Fire Bottle Support Angle Cracks

**SIKORSKY
AIRCRAFT
DESIGN RECORD BOOK**Record NO: Prepared by Kenneth WelchDRB No: 2018-SA-92-085Title Fire Bottle Support Angle CracksStart Date: 10/9/2018Detail Dwg 92210-03382End Date: Assy Dwg 92201-03140No. Pages:

Figure 1 – Crack Locations

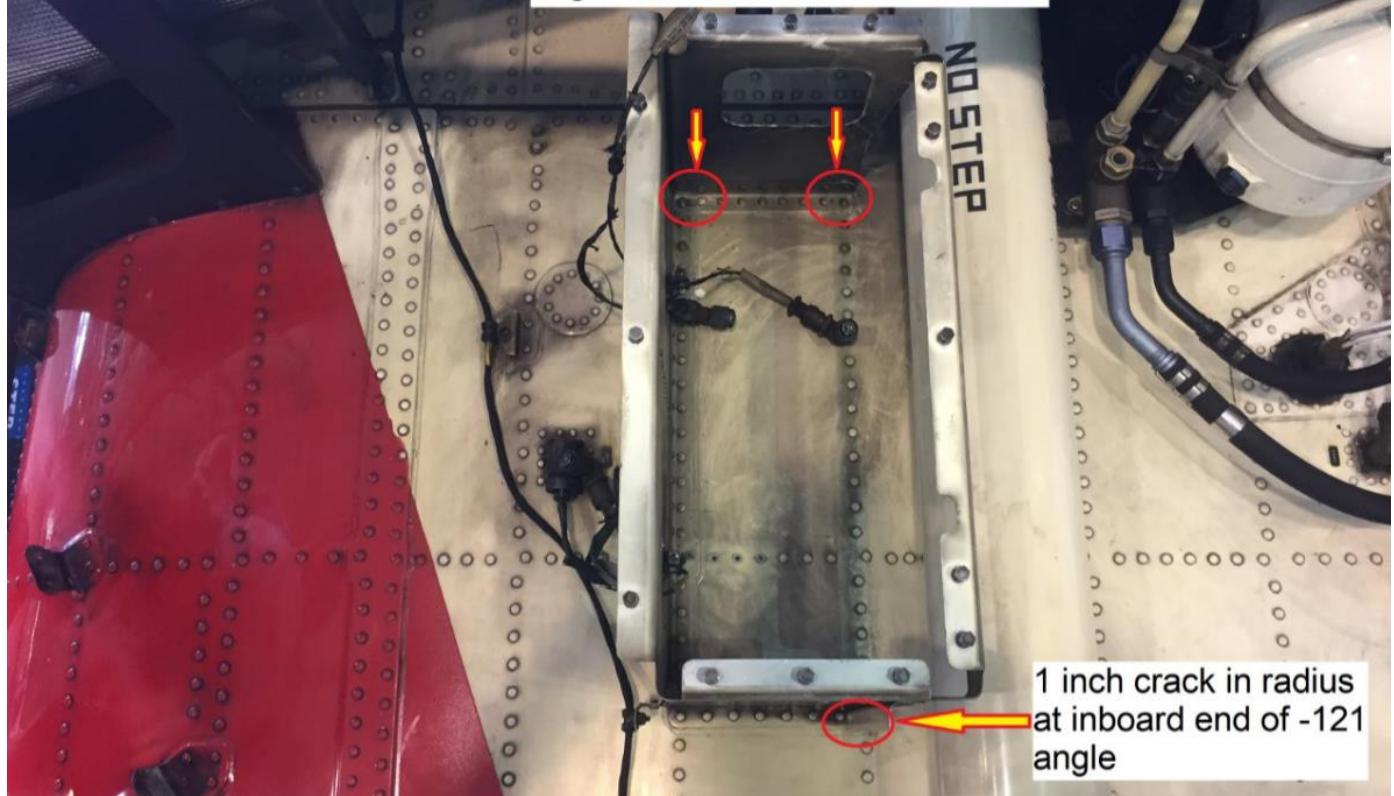
During a 1500 hour scheduled maintenance inspection TAS maintainers found a one-inch long radius crack on either end of the P/N 92210-03382-113 fire bottle support forward angle, and a one inch radius crack on the inboard end of the -121 aft angle.

1 inch crack in radius of -113
angle inboard and outboard ends

1. Prepare the ship for ground maintenance.
2. Gain access to the cracked fire bottle attach angle.
3. Remove the fire bottle attach angles from the aircraft by drilling out the rivets. Vacuum the area to remove any loose particles.

4. Inspect area for any other cracks or anomalies. If any are found, report to Sikorsky Aircraft.
5. Fabricate a new attach angle from 0.040" thick , 301 1/4 hard stainless steel sheet, using the existing angle as a template. Break all sharp edges 0.005-0.015 in radius. The 90 degree bend radius is .12".

6. Measure and transfer the rivet hole locations from the existing angle to the new angle and drill the rivet holes. De-burr the rivet holes and the edges of the angle. Vacuum the area to remove any loose particles.

7. Degrease the new angle by wiping with a low-lint cleaning cloth (conforming to A-A-59323, Type II) using acetone (conforming to ASTM D329) or ethyl alcohol (conforming to A-A-51693). Wash with clean water to a water-break free condition.

8. Brush cadmium plate the new angle per MIL-STD-865.
9. Apply one coat of MIL-PRF-23377 or MIL-PRF-85582 epoxy primer to the new angle and allow to cure.

10. Prior to the final installation, lightly coat the mating surfaces of the doubler with one of the following sealants, in order of preference: MIL-S-81733 or AMS 3265, Class A-2.

11. Rivet the new angle into position with MS20470AD5-6D rivets. Blind rivets may be used if necessary (ensure proper fit and edge distance). Wet install the fasteners with one of the following sealants, in order of preference: MIL-S-81733 Type IV-12 or AMS 3265, Class A-2.

12. Apply another coat of MIL-PRF-23377 or MIL-PRF-85582 epoxy primer to the repair area and allow to cure.
13. After the sealant has cured, scrape off any excess with a non-metallic scraper.

14. Re-install the items removed in Step 3 per the Maintenance Manual.
